**BOARD OF PUBLIC WORKS AND SAFETY  
Agenda Request Form**

RE: Franklin Greenways Trail Amphitheater  
Change Order #1

RE: Franklin Greenways Trail Amphitheater  
Change Order #2

RE: Franklin Greenways Trail Amphitheater  
Change Order #3

C1200

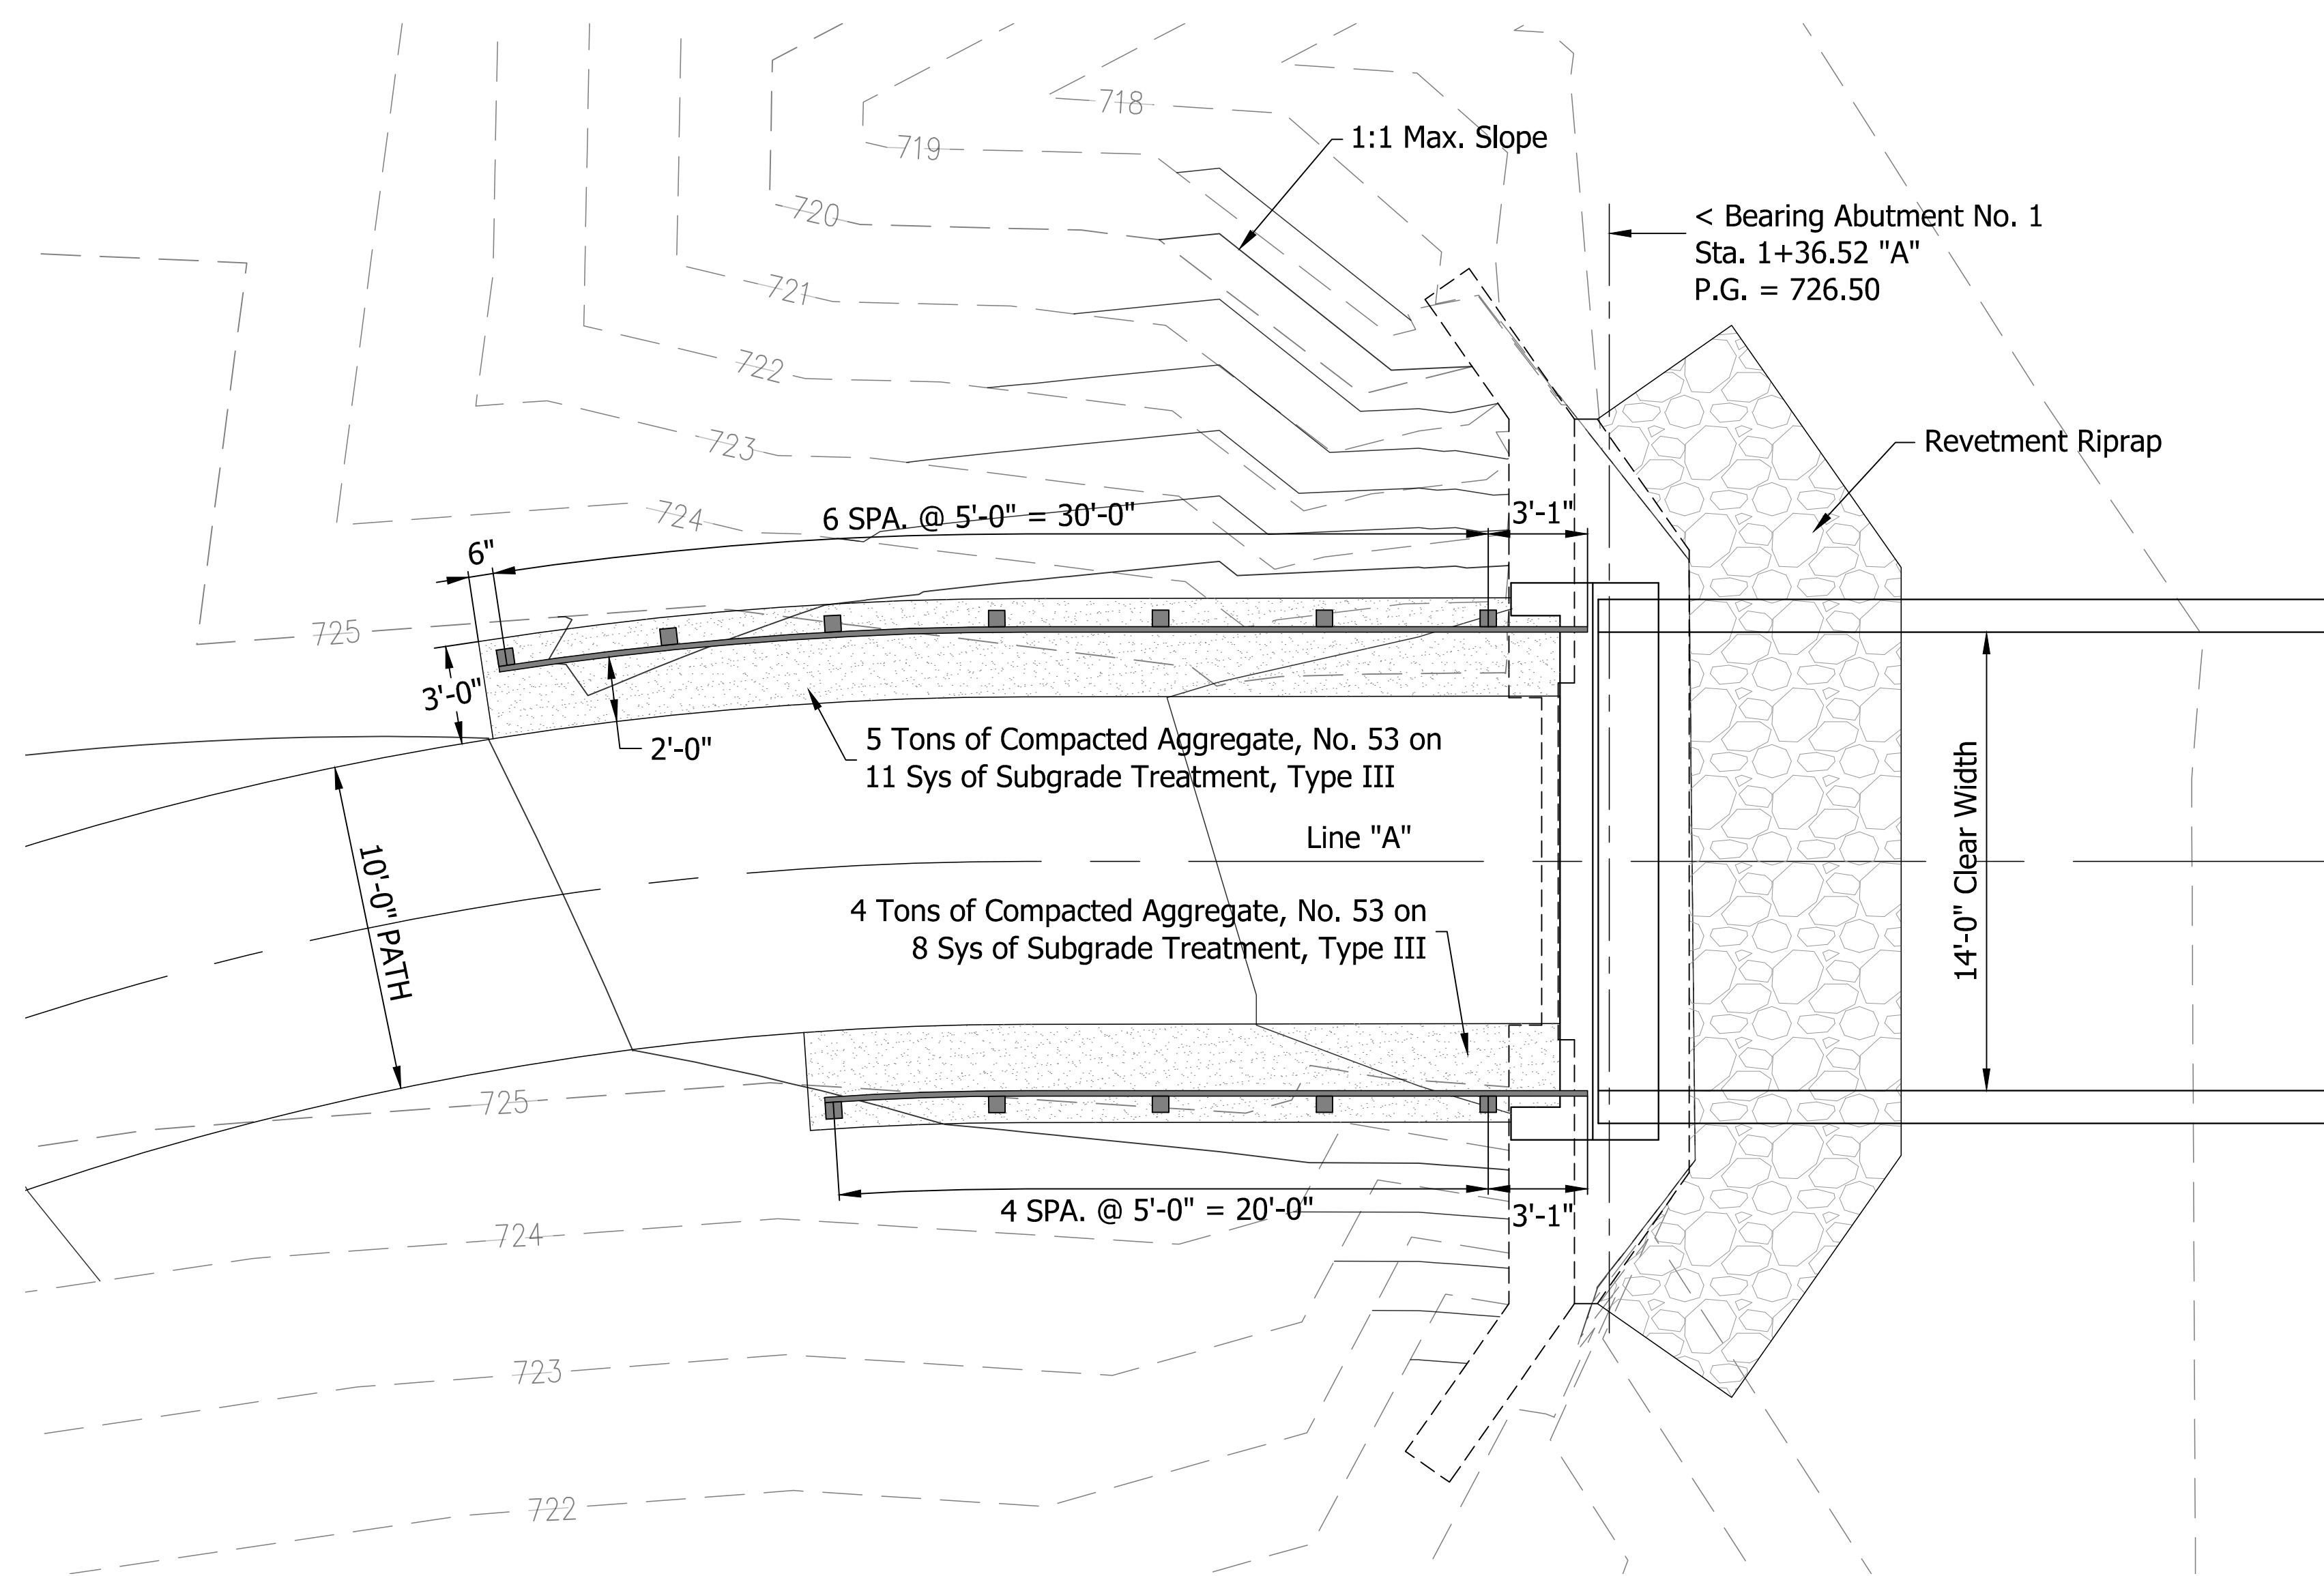
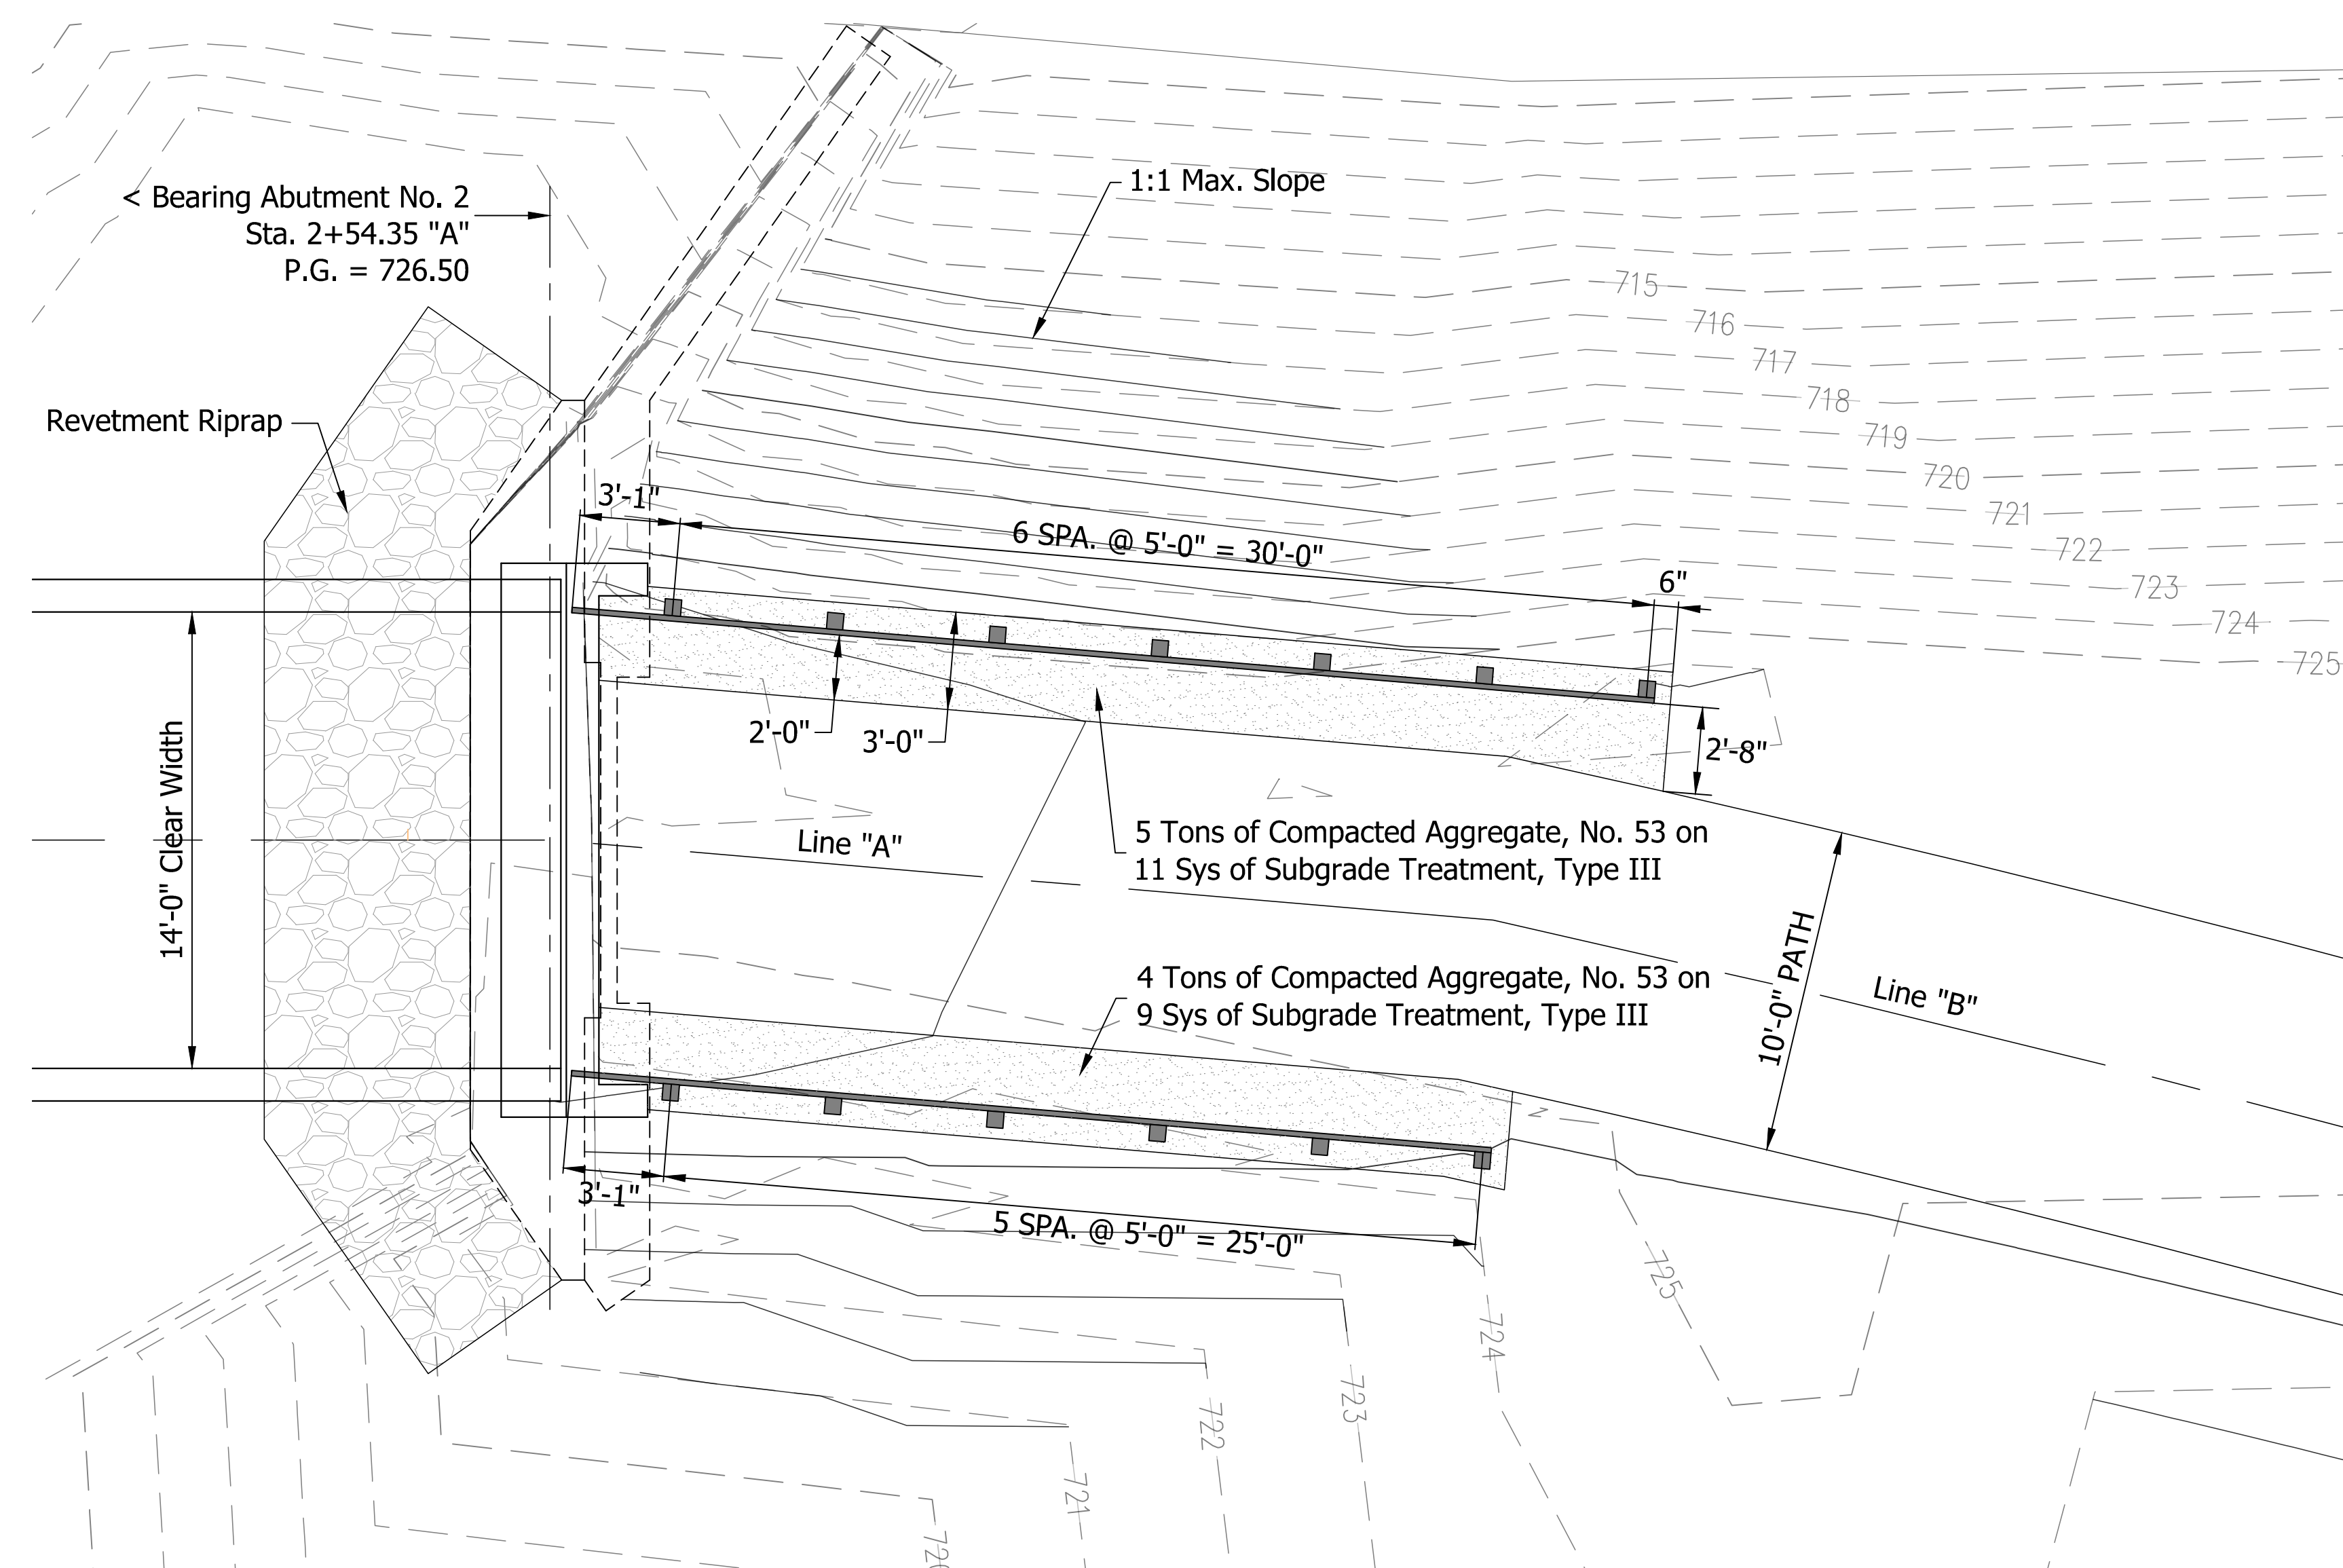
After reevaluating the side slopes on all four (4) corners where the HMA path ties into the pedestrian bridge deck, CrossRoad Engineers has determined that a timber safety railing needs to be installed on all corners. A three-foot-wide compacted stone shoulder will also need to be installed along the trail in these areas.

Please see the railing detail attached in this price request and provide a unit price to complete the installation of the railing and the compacted aggregate shoulders. Pricing shall be provided on a per linear foot basis for the railing and a per ton basis for the aggregate and in accordance with INDOT standard specification 109.05(a). The work shall be completed in accordance with the attached standard specifications.

The timber railing end treatments shall be located at all corners of the bridge. The top rail of the end treatment shall have a top rail height that matches the top of the second rail on the bridge railing, between 42 and 45 in. The spacing of the remaining rails shall match the spacing used on the timber bridge railing. A 4 in. gap shall be provided between the end of the truss railing and the beginning of the end treatment.

Timber posts shall be spaced as shown in the contract plan sheet (C1200). The posts shall be placed in holes measuring 12 in. in diameter and 42 in. deep. The bottom of the post shall be located 36 inches below the finished ground elevation. Posts shall be aligned parallel to the path and braced in a vertical position. Concrete shall be placed around the post to within 6 in. of the finished ground elevation.

The rails shall be attached to the post using two 5/16 in. by 4 in. galvanized lag screws with galvanized washers per rail per post. Holes shall be pre-drilled and countersunk the total depth of the lag screw head and washer, providing a flush finished surface with no protrusions. 3' wide compacted aggregate shoulders shall be constructed as shown in the plans.
